### REVISED NOTICE OF DECISION

DATE OF NOTICE: October 10, 2016  
FILE: SP-12-16  
TYPE OF APPLICATION: Site Plan Review (Type I-L) for new construction of a two-story 16,000-square foot office building, a new parking lot containing 107 spaces, storm water facilities, and landscaping.  
REVIEW BODY: Staff  
PROPERTY OWNER: Mark A. Shelnitz, Secretary; W.R. Grace & Co.- Conn; 7500 Grace Drive; Columbia, MD 21044  
APPLICANT: Shawn Conway, Plant Manager; W.R. Grace & Co.; 1437 Industrial Way SW; Albany, OR 97322  
APPLICANT REP.: Jeff Schott, P.E.; Pillar Inc.; 835 NW 23<sup>rd</sup> Street; Corvallis, OR 97330  
PROJECT MANAGER: Vic Forchette; W.R. Grace & Co.; 1437 Industrial Way SW; Albany, OR 97322;  
ADDRESS: 1437 Industrial Way SW  
MAP/TAX LOT: Linn County Assessor's Map No. 11S-03W-07CB; Tax Lot 2626  
ZONING: Light Industrial (LI) District

Project Name and Address  
**SITE LAYOUT**  
BLDG 9 SITE PLAN APPLICATION  
W.R. GRACE  
ALBANY, OREGON

1 SITE LAYOUT  
C1.3  
SCALE 1" = 20'

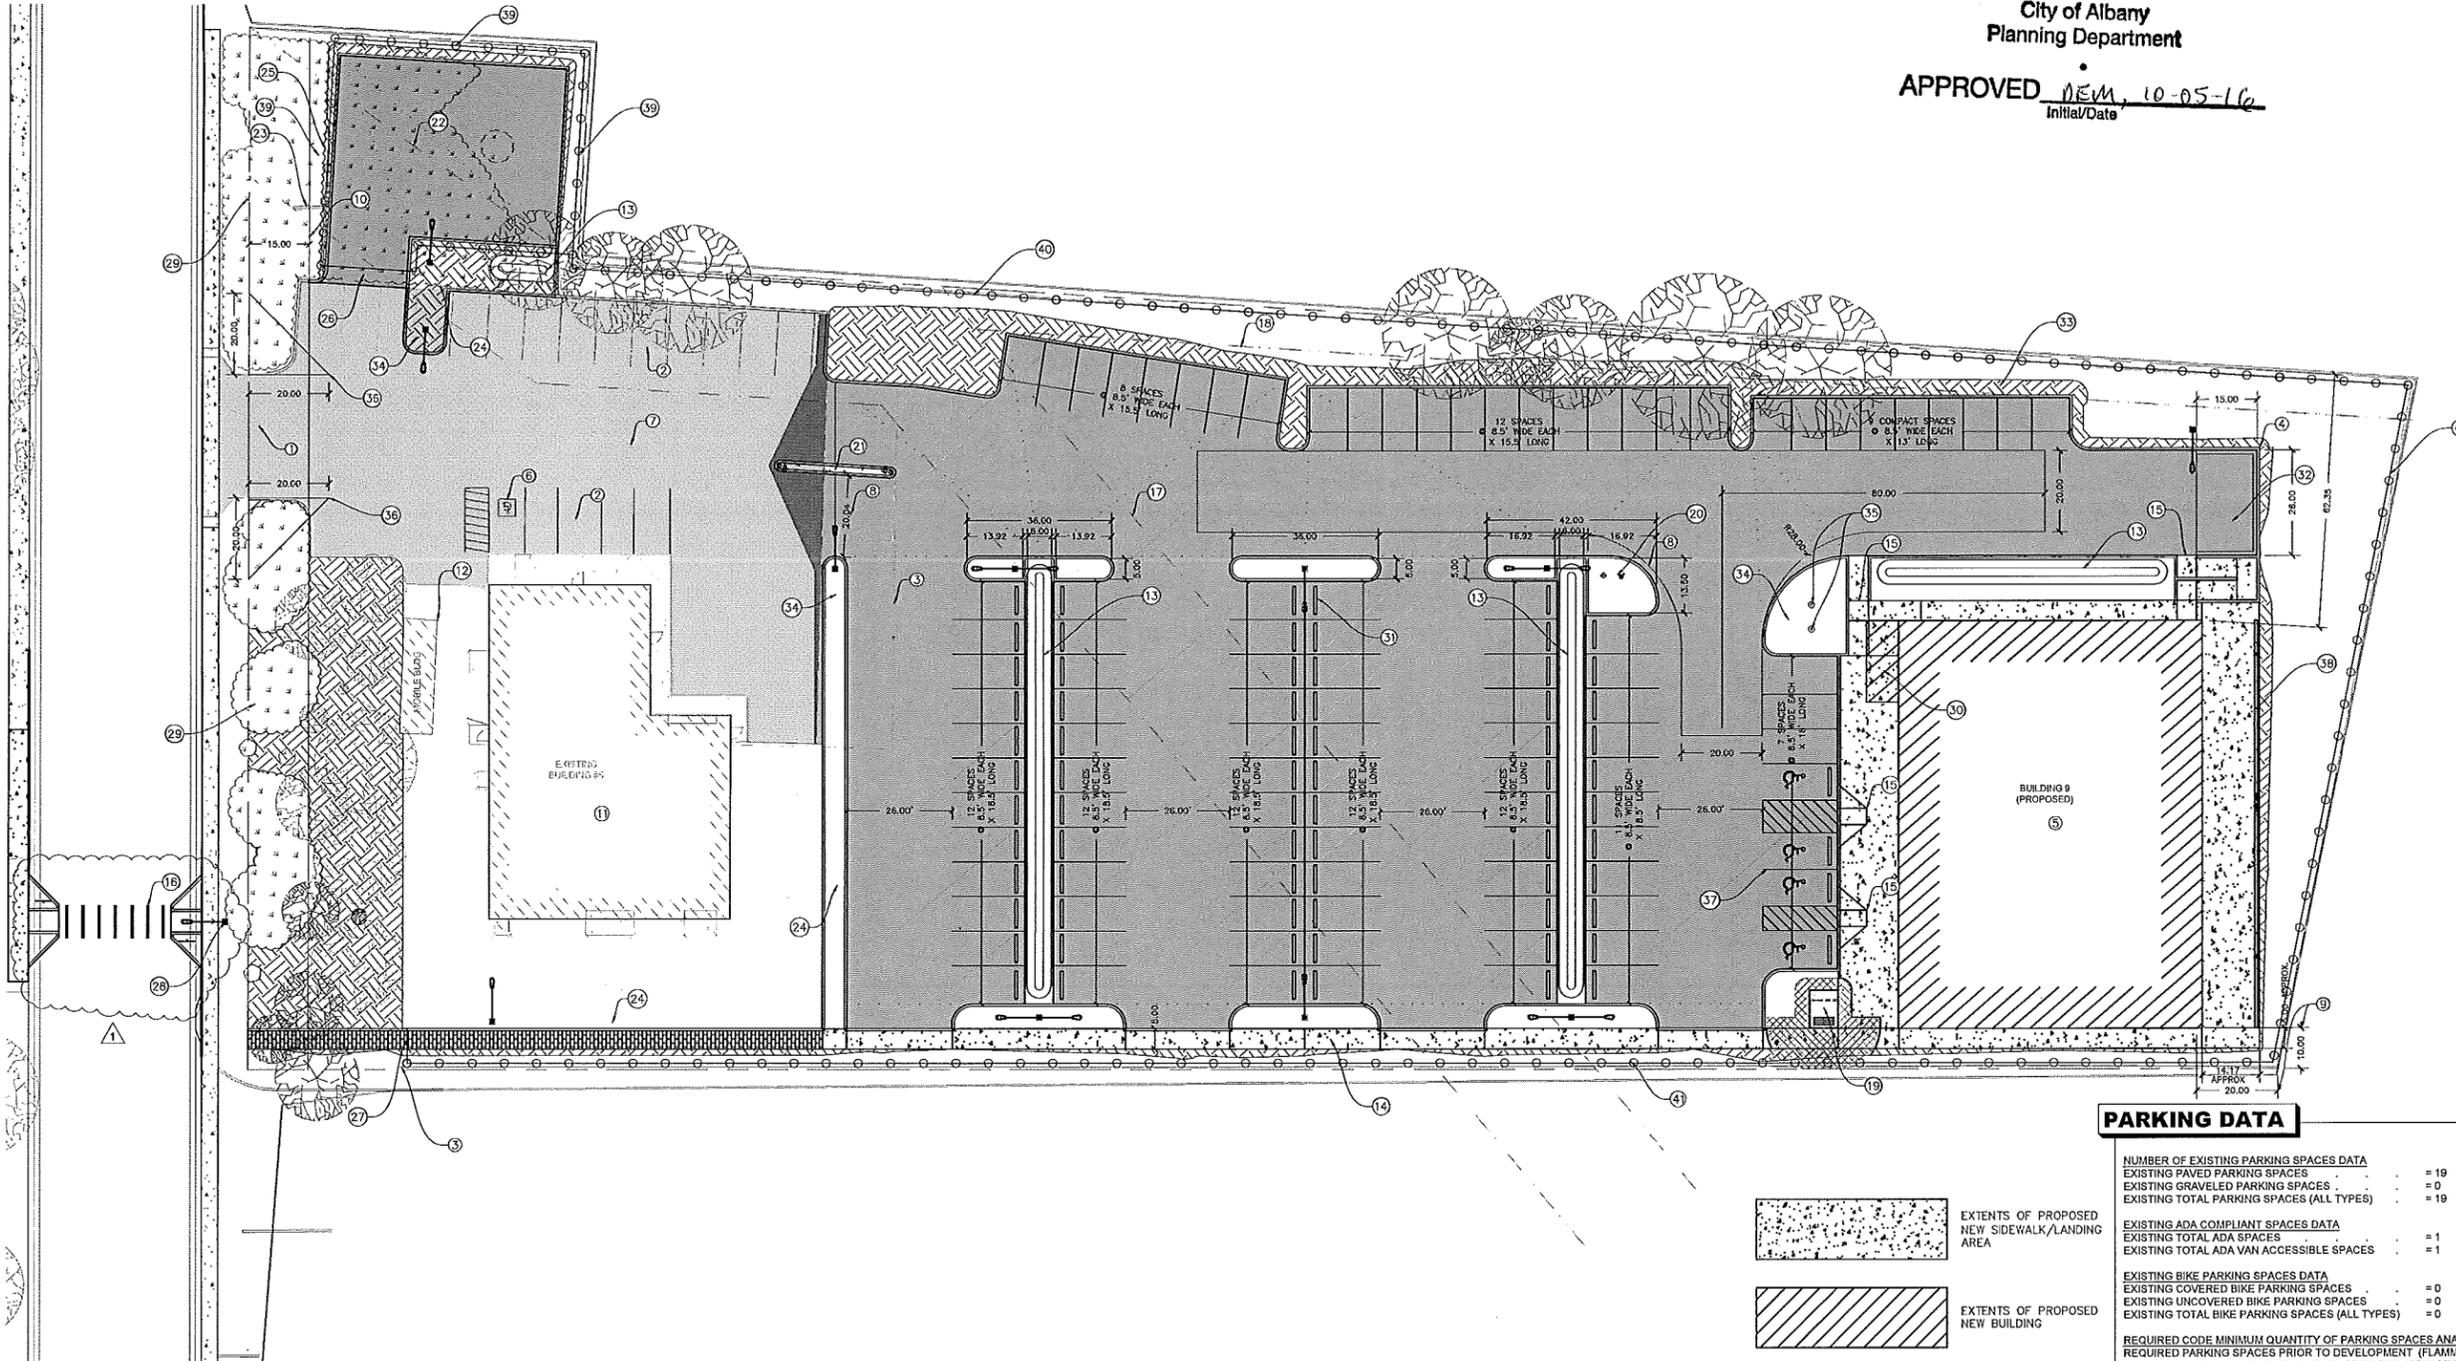
- ~~3.1 Prior to issuance of an occupancy permit, the applicant shall install public sidewalk to city standards across the frontage of the site on Industrial Way. This condition is deleted. Sidewalk already exists at this location.~~

- 4.1 Prior to issuance of a final occupancy permit, a minimum of 97 vehicle parking spaces shall be provided.
- 4.2 A detail drawing showing the new location of the bicycle parking spaces, at least half covered and all meeting required clearance standards, shall be submitted to the Planning Division for review and approval prior to issuance of a building permit. All required bicycle parking shall be installed prior to occupancy.

- 5.3 The outdoor storage area shall be screened by a six-foot sight-obscuring fence. If privacy slats are used, the Development Code requires opacity of at least 75% when viewed from any angle at a point 25 feet from the fence.
